AMENDMENT TO THE DRAWING

REMARKS

FIG 1

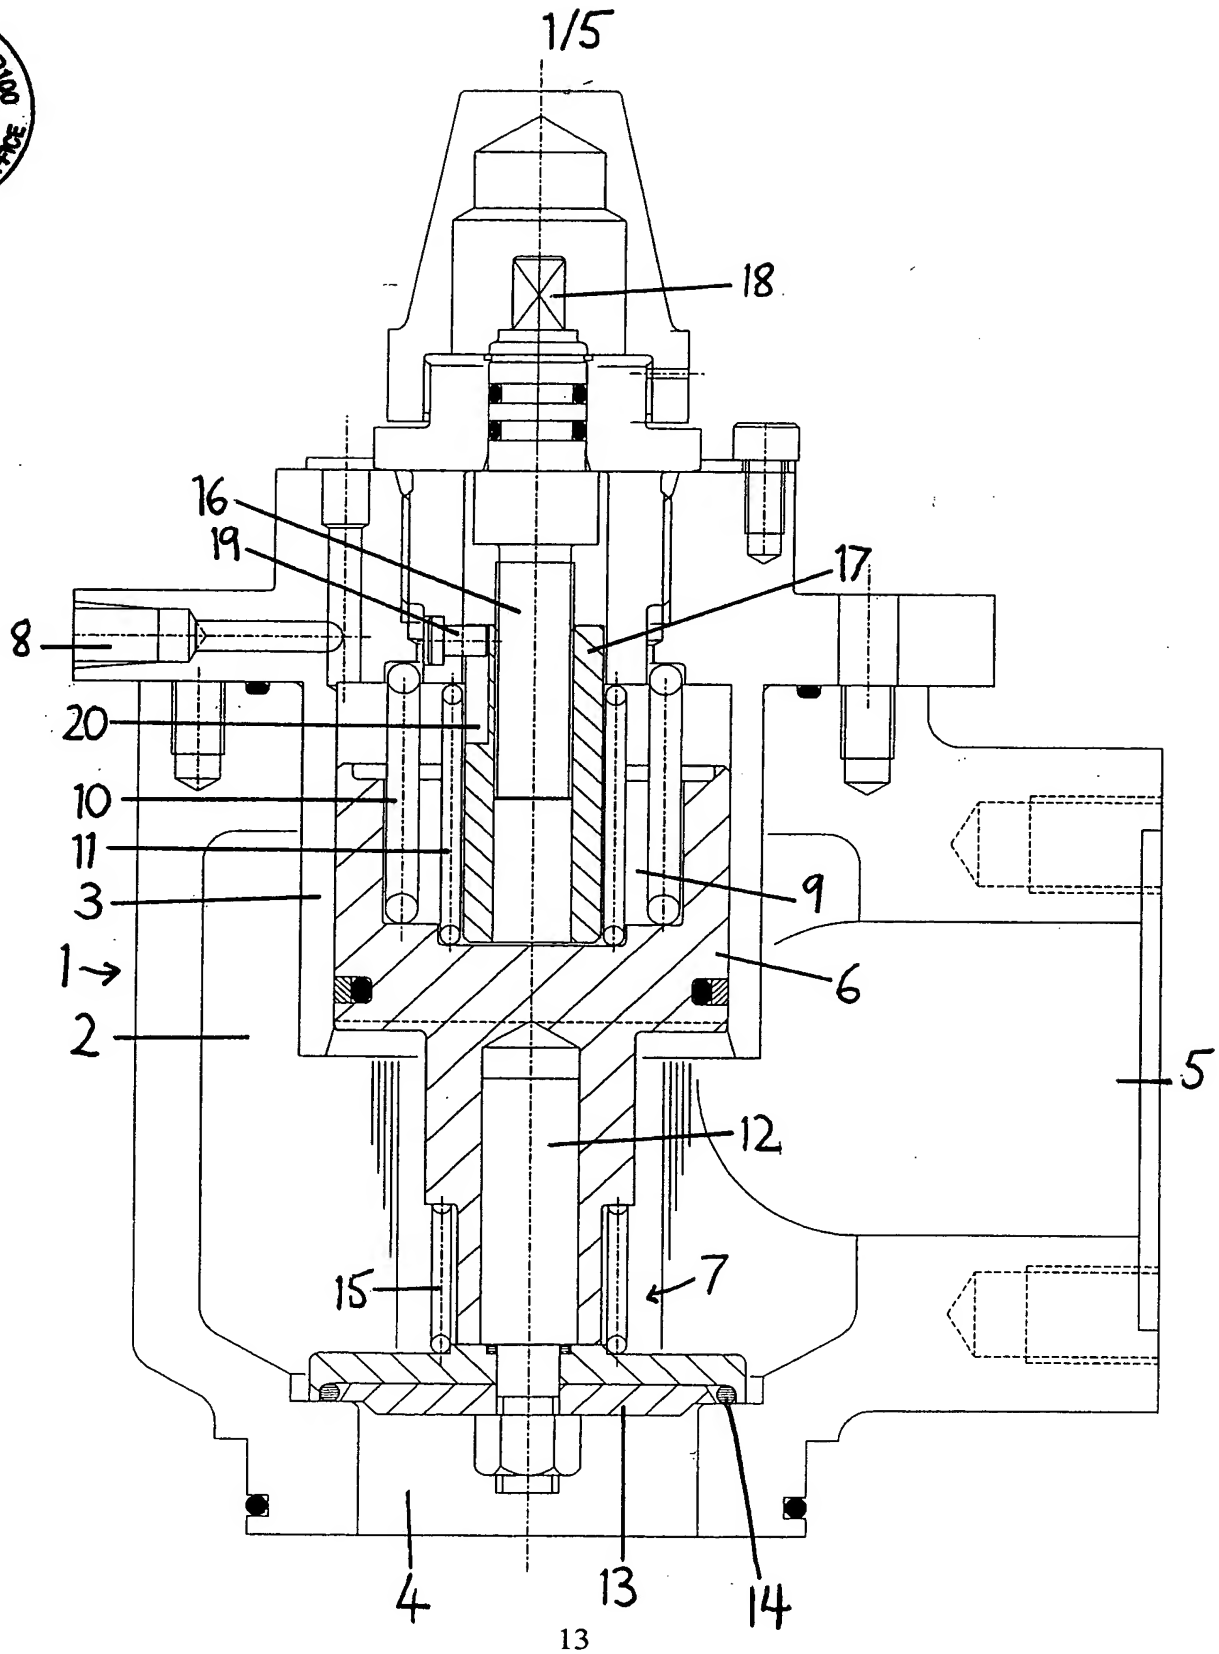
In FIGURE 1:

Add the numeral "14" for the O-ring associated with closing disk 13.

The drawing is objected to because the identification numeral "14" which appears in the specification does not appear in the drawing. The drawing is amended at Figure 1 to add the identification numeral "14" for consistency with the specification. Specifically, the numeral "14" is added to identify the O-ring associated with closing disk 13, as shown on the red-line copy of Figure 1 herewith. Support for the amendment is found, for example, in the specification at page 5, line 14. Replacement drawing sheets including the foregoing amendment are submitted herewith.
